As Constructed

WEST PETERSBURG APPROACH & FLOAT

PROJECT NO. W6216

As Built

ELEVATION

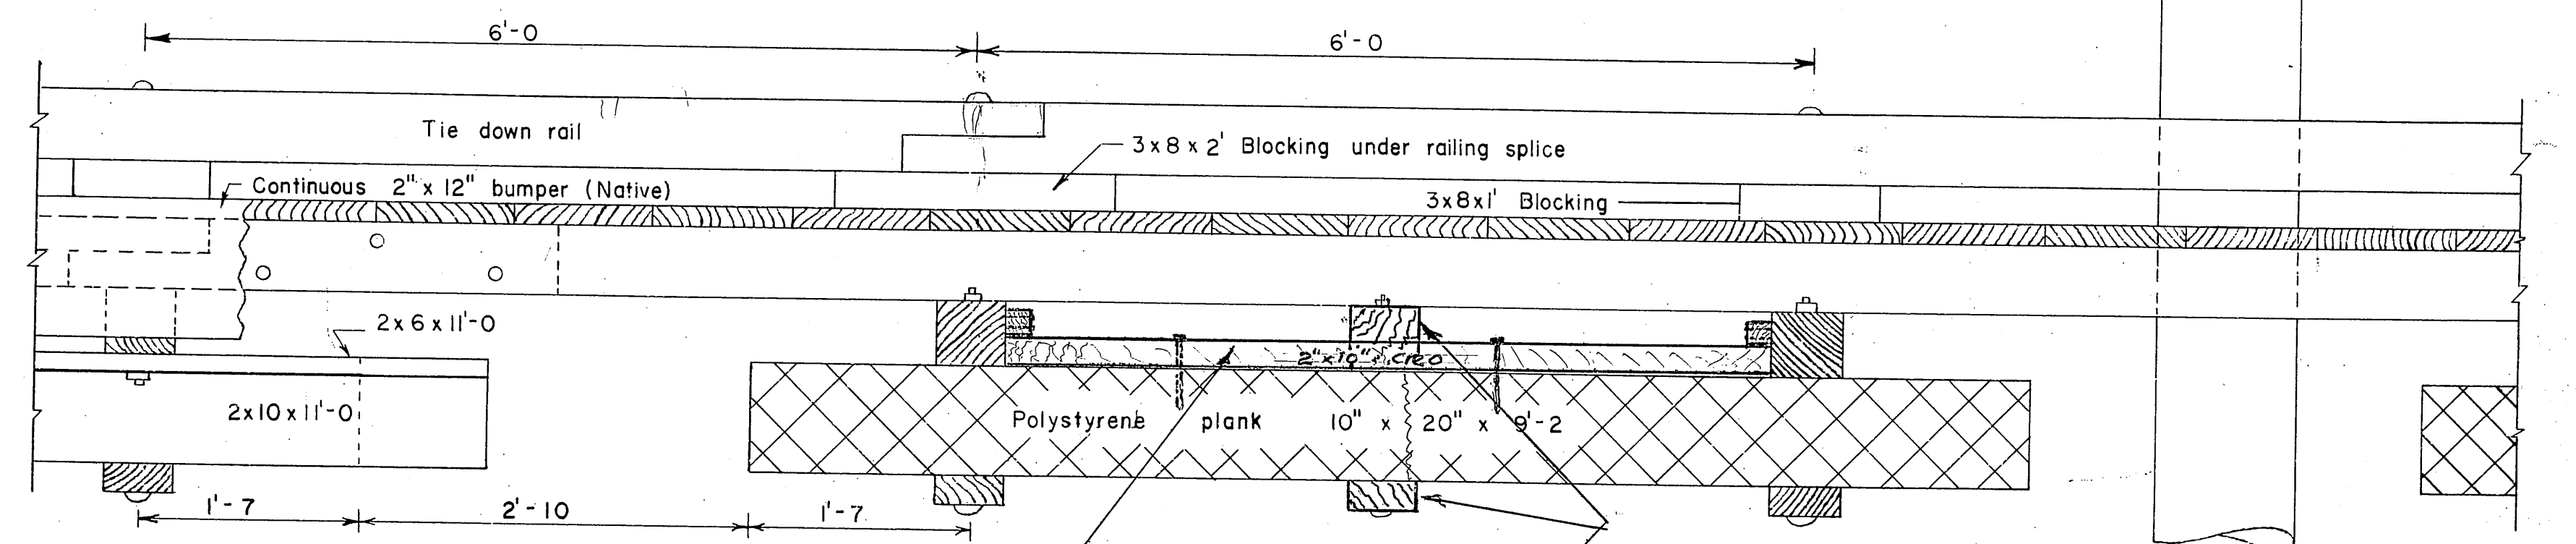
Styro plank broken on Northwest end of float. Repair made as shown.
Ramp float has added 3"x6" & 6"x6" Sills on the two sections under ramp due to that end of float going dry on minus tide run-outs.
